STAFF REPORT
COMMUNITY DEVELOPMENT DEPARTMENT

HEARING DATE: 4/23/2024
TO: Mayor & City Council
FROM: Linda Ritter, Associate Planner
208-884-5533
SUBJECT: FP-2024-0002
Hadler Subdivision No. 1 - FP
LOCATION: Located at 7200 S. Locust Grove Road, approximately 1/2 mile south of the Locust Grove and Lake Hazel intersection on the east side of Locust Grove, in the N 1/2 of the SW 1/4 of Section 5, Township 2N, Range 1E.

Final Plat consisting of 51 building lots and 5 common lots (1 common driveway and 4 landscape) on 9.74 acres of land in the R-15 zoning district for Hadler Subdivision No. 1.

B. Final Plat (dated: 3/13/2024)

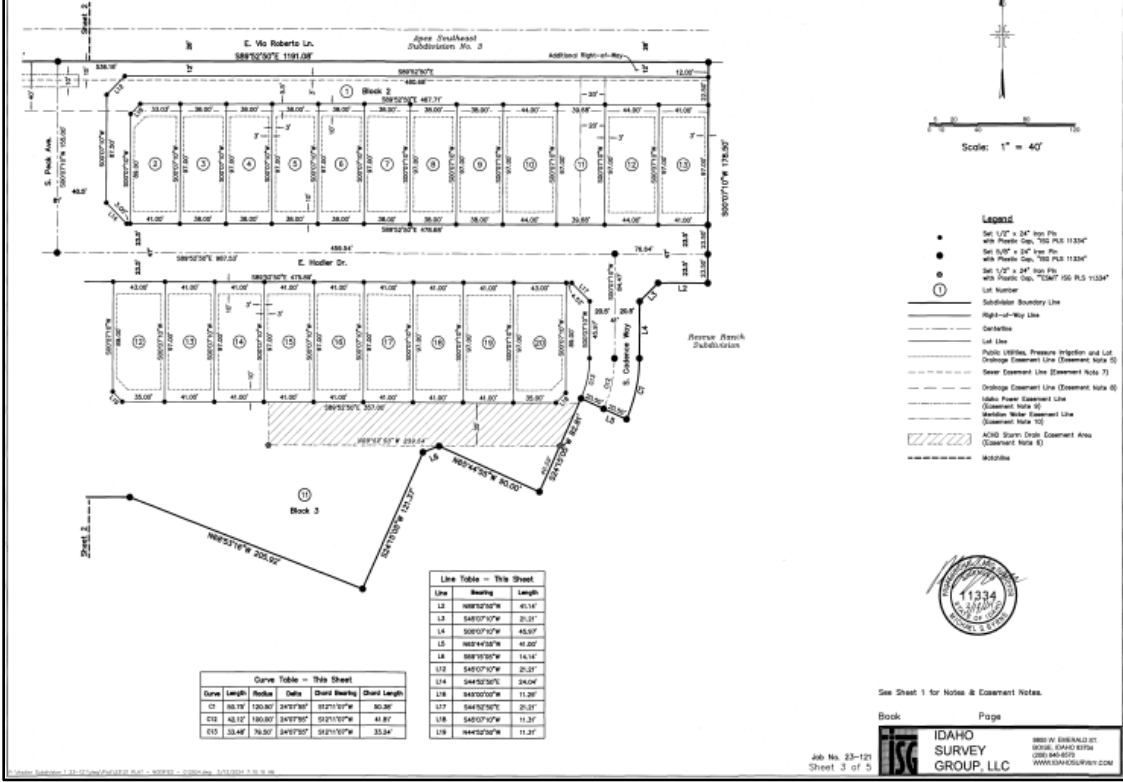
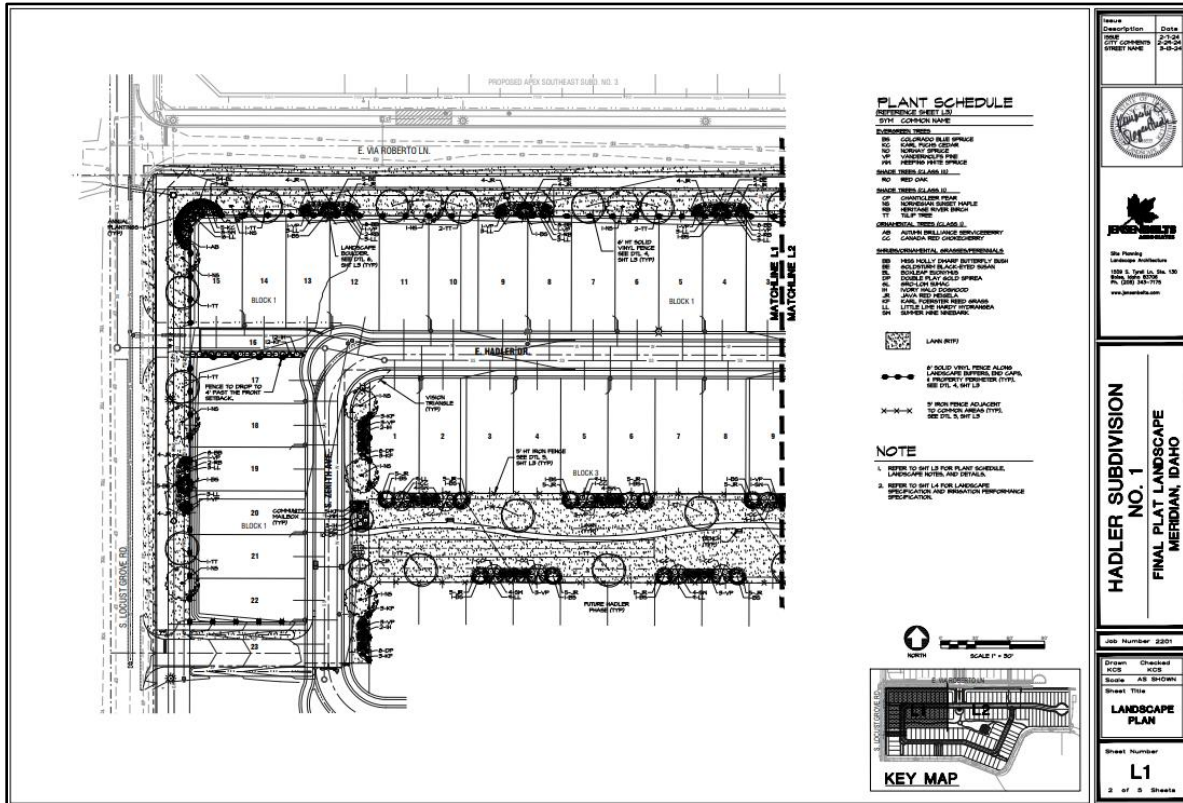
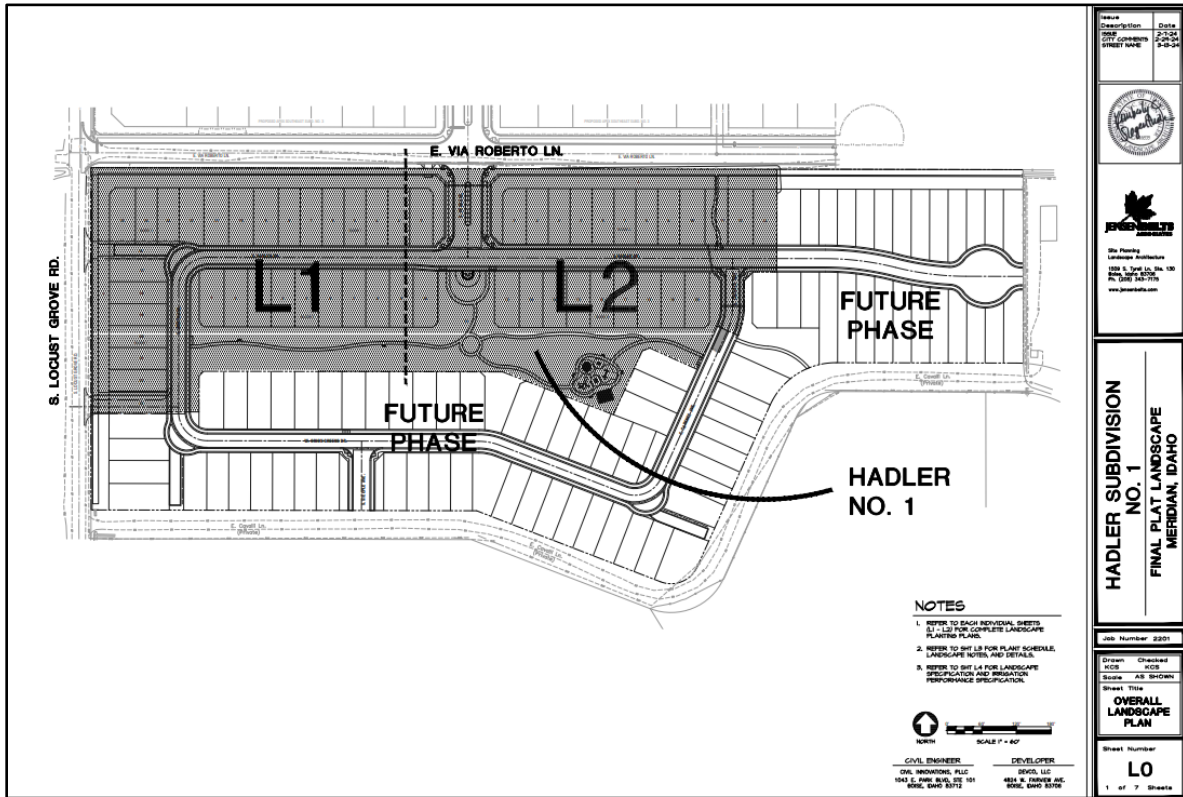
1. Applicant shall comply with all previous conditions of approval associated with this development: H-2022-0064 (AZ, PP) and DA Inst. #2023-023846.
2. The final plat shown in Section V.B, prepared by Idaho Survey Group, LLC, stamped on 1/30/24 by Michael S. Byrns, shall be revised prior to signature on the final plat by the City Engineer, as follows:

- a. Note #10: Include the recorded instrument number of the City of Meridian water easement.
 - b. Note #11: Include the recorded instrument number of the City of Meridian sewer and water easement.

- c. Note #12: Include the instrument number for the ACHD permanent easement.
 - d. Note #13: Include the instrument number for the temporary blanket ACHD access easement.

- e. Note #14: Include the instrument number for the ACHD license agreement.
 - f. Consistent with ACHD conditions of approval, provide traffic calming measures along E. Hadler Drive to help mitigate its long and straight design.
